RE: Resolution Copper Mine Project and Land Exchange DEIS

The above groups wish to thank the U.S. Forest Service (USFS) for the opportunity to comment on the Resolution Copper Mine (RCM) Project and Land Exchange Draft Environmental Impact Statement (DEIS). As you are aware, these groups submitted detailed scoping comments for the project on July 18, 2016. These comments are also intended to address the Draft Practicability Analysis In Support of Clean Water Act 404(B)(I) Alternatives, prepared by Westland Resources on Behalf of Resolution Copper for the U.S. Army Corps of Engineers (Corps) as well the proposed 404 permit application and Corps review.

The DEIS is deficient in numerous critical areas, fails to provide a full range of reasonable alternatives, fails to provide a full analysis of the impacts of those alternatives, fails to apply the full scope of federal laws applicable to the project, improperly regulates/reviews the mine under assumed “rights” under federal mining laws without the required factual support, fails to take the required “hard look” under NEPA, and otherwise violates federal law. The USFS/Corps must

Figure 18 Emerman, “Since the Above”: Since the above map includes both the footprint of the 1% Cu shell as well as other geographical information, it can be used to spatially locate the fault map in Fig. Emerman, “The Most Important.” Figure from Resolution Copper Mining (2014b).

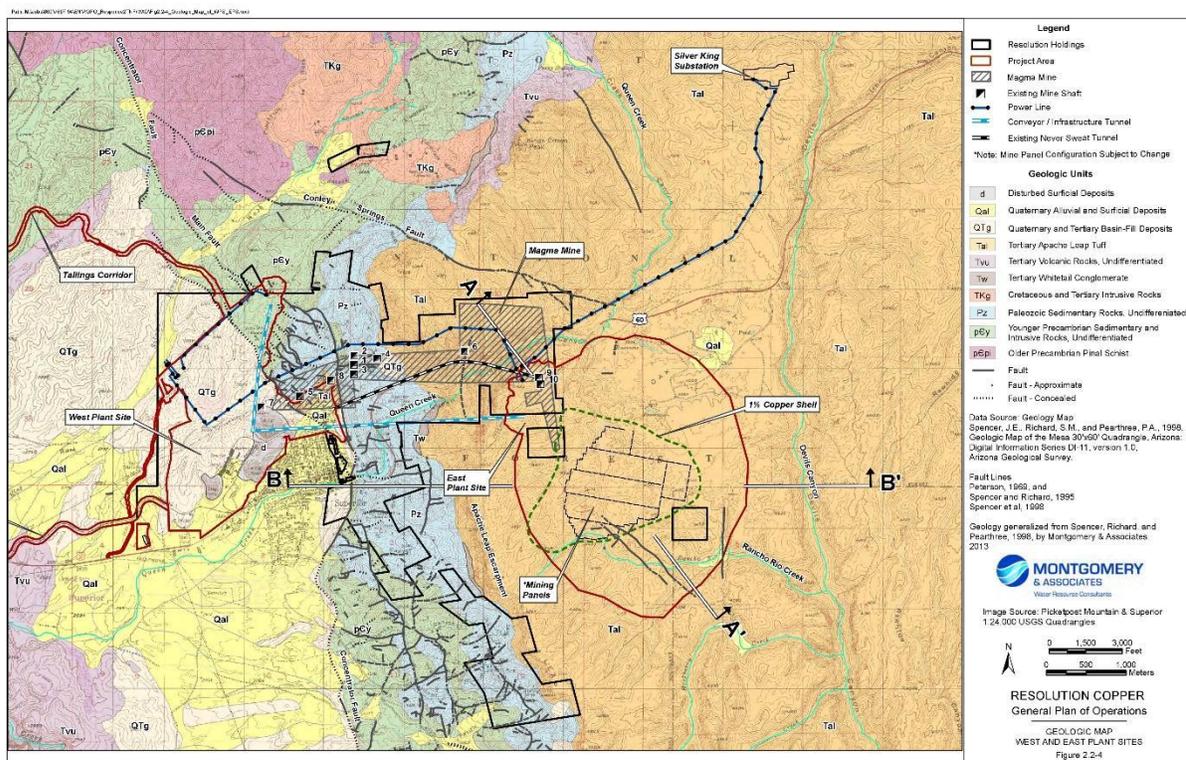
subsidence. In particular, the primary control on the ability of the panel caving to transmit deformation to Apache Leap should be any faults that connect Apache Leap to the surface footprint of the panel caving area. From this perspective, the most important fault is the West Boundary Fault (see Fig. Emerman, “The Most Important”). The fault map is difficult to interpret because it does not include any geographical information (see Fig. Emerman, “The Most Important”). However, the fault map does include the outline of the 1% Cu shell (footprint of the volume within which the ore has a grade of greater than 1% copper), so that it can be aligned with the geological map from Resolution Copper Mining (2014c) that also includes the 1% Cu shell, as well as the footprint of the mining project area and other geographical information (See Fig. Emerman, “Since the Above”).

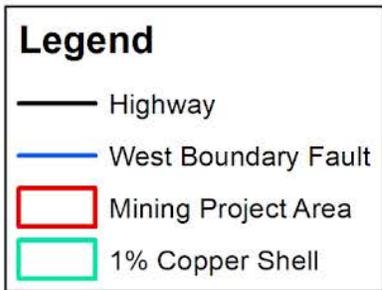
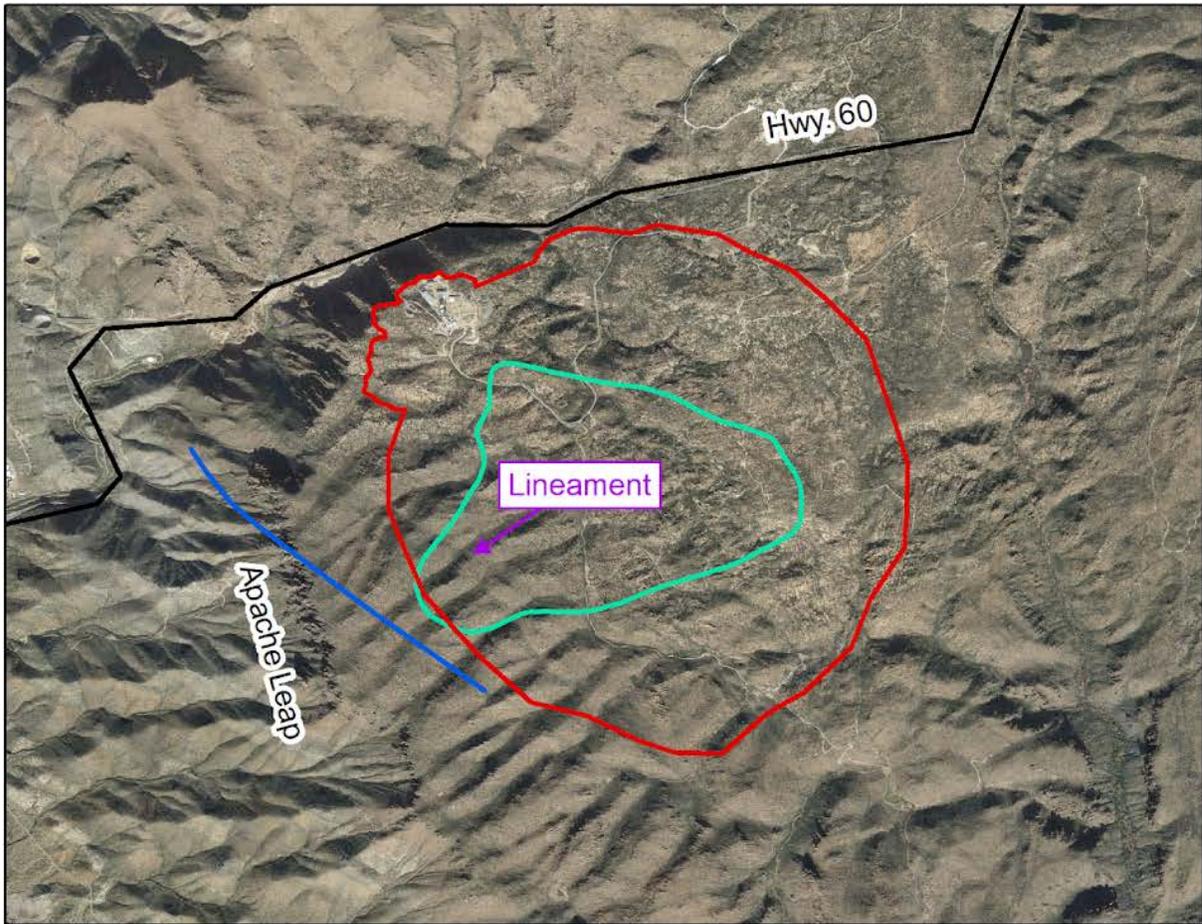
The superposition of the West Boundary Sites Fault (as mapped in Fig. Emerman, “The Most Important”) onto a Google Earth image (a seamless integration of aerial photography and satellite imagery) shows a pronounced surface feature (labeled as a lineament) that is subparallel to the West Boundary Fault and offset from the fault by about 2000 feet (see Figs. Emerman,

“The West Boundary-A & -B” The lineament should not strictly be assumed to be a fault, but a fracture trace, that is a linear feature that is visible from aerial photography or satellite imagery (Fetter, 2001). (Lineaments are fracture traces that are longer than 1500 meters.) Lineaments may be surface expressions of deep-seated zones of structural weakness, such as geological faults, but that must be verified by surface or subsurface mapping. However, the nearly-parallel orientations of the West Boundary Fault and the lineament are certainly suggestive that the West Boundary Fault has been incorrectly mapped, and there is no other mapped fault that could correspond to the lineament (Figs. Emerman, “The Most Important” & “The West Boundary-B”). Unlike the mapped West Boundary Fault, the lineament intersects the caved rock zone (Fig. 4a), so that there is potential for deformation to be transmitted from the caved rock zone to Apache Leap if the lineament is indeed a plane of structural weakness, such as a fault. On this basis, there could have been an underestimation of the extent of the subsidence zone.
